**IN THE MATTER** of Proposed Private Plan Change  
95 to the Western Bay of Plenty  
District Plan First Review –  
Pencarrow Estate, Pongakawa

**STATEMENT OF EVIDENCE OF JAMES ABRAHAM ON BEHALF OF  
WESTERN BAY OF PLENTY DISTRICT COUNCIL IN RESPONSE TO  
QUESTIONS FROM HEARING COMMISSIONERS  
(WASTEWATER AND STORMWATER)  
22 November 2024**

### RAINSMART® SUGGESTED MAINTENANCE PROCEDURES

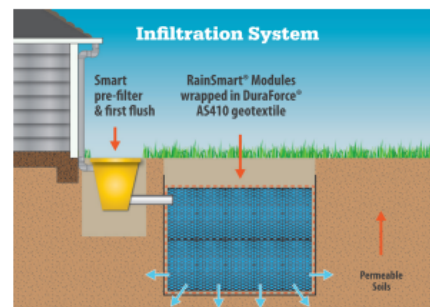
- With regards to maintenance Lysaght have specifically mentioned a rain smart system in Appendix 3 of the Engineer Servicing Report. This system is commonly used today. I have included below the inspection and cleaning procedures recommended by the manufacturer. The suggested procedure recommends inspection tasks are undertaken annually and after every heavy rainfall event these tasks include CCTV inspections, soakage testing and monitoring. Methods of flushing / cleaning require excavation around the soakage device, flushing and the use of a sucker truck or similar. In my experience these procedures require technical knowledge which is beyond the means of most homeowners. As the proposed

networks efficiency is reliant on these privately owned systems it is critical that these are maintained. This burden falls on Council. While Council have provisions in section 3.3 of its Stormwater Bylaw “Council may require an owner/ occupier to fix or upgrade a private stormwater network, at the owner’s cost, to meet original design specifications”, the Council does not currently resource the monitoring and enforcement required to ensure compliance.

## Attachment "C"

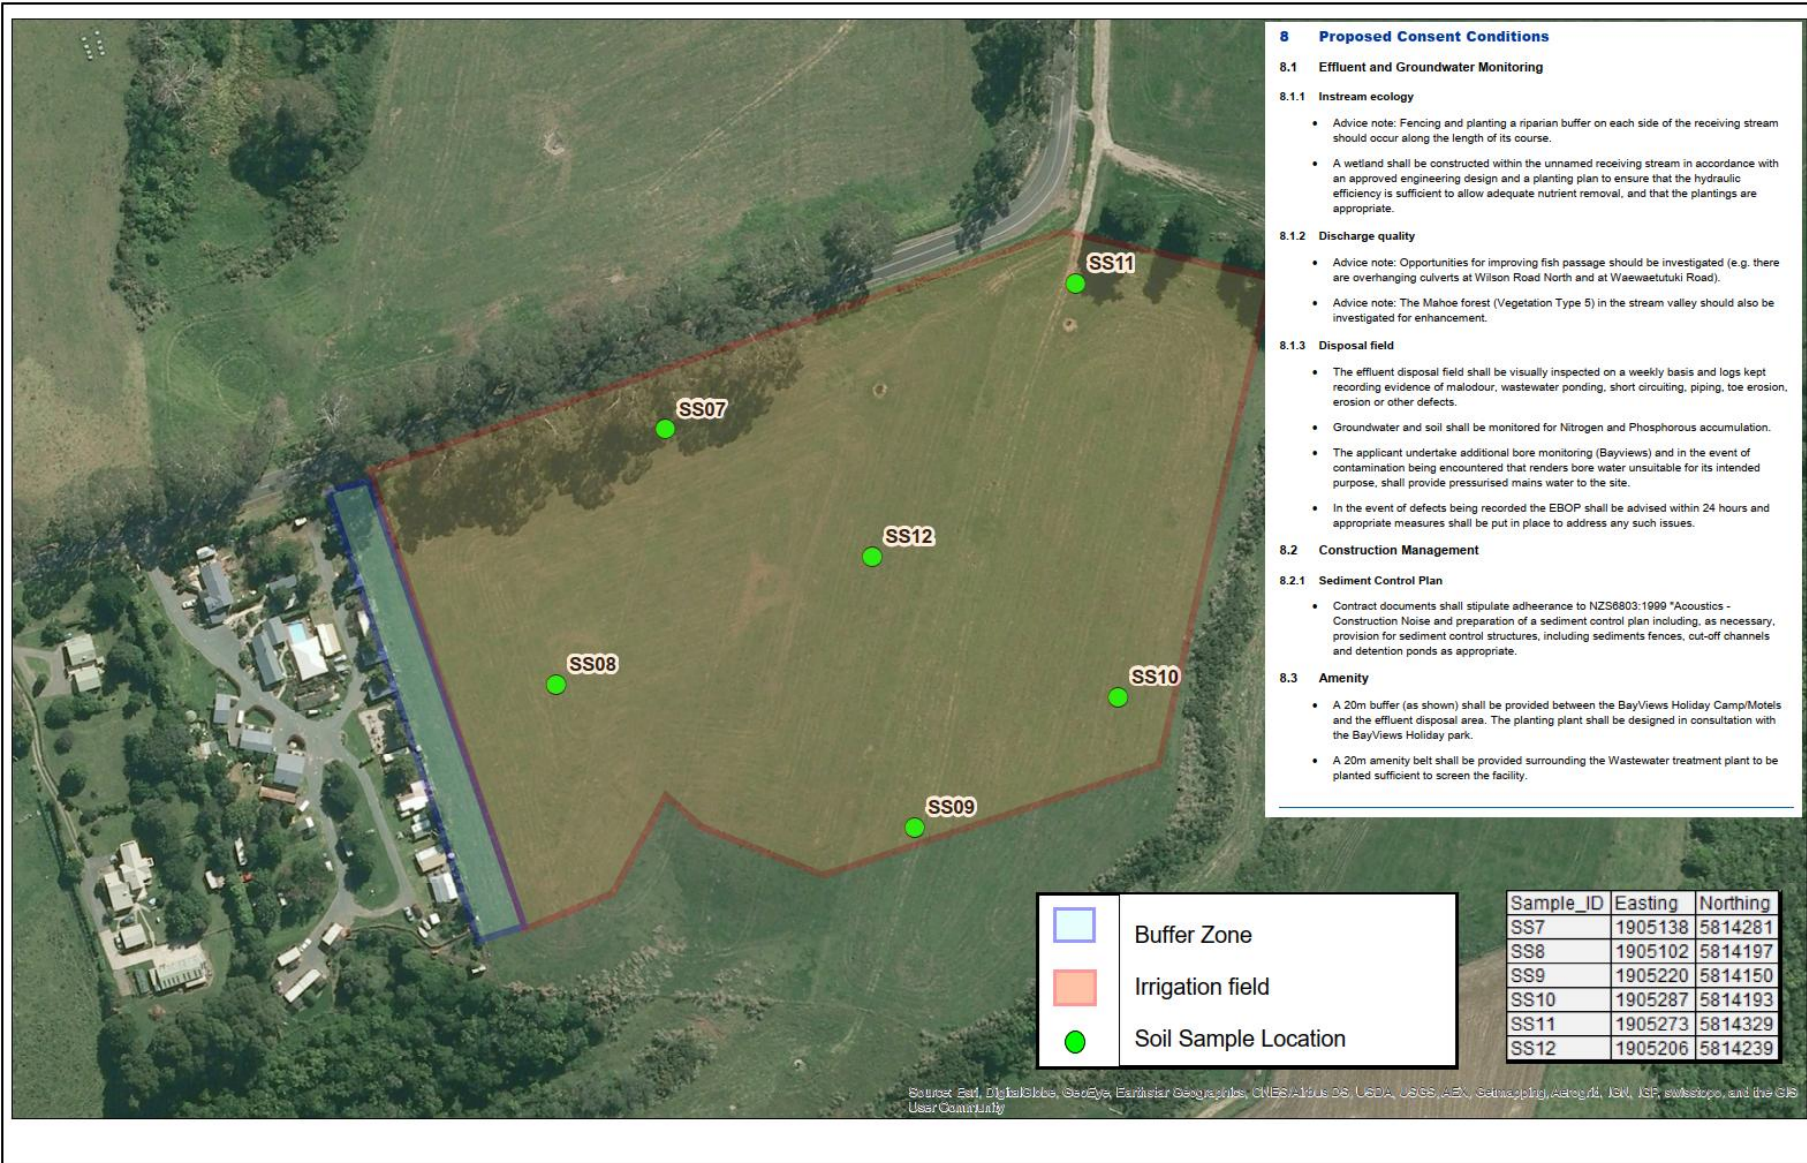
17. Based on Council's experience with the Maketu wastewater irrigation field a 20m buffer from the residential area would be sufficient. Attached to this statement as **Attachment C** is a plan showing the buffer zone required in that situation.
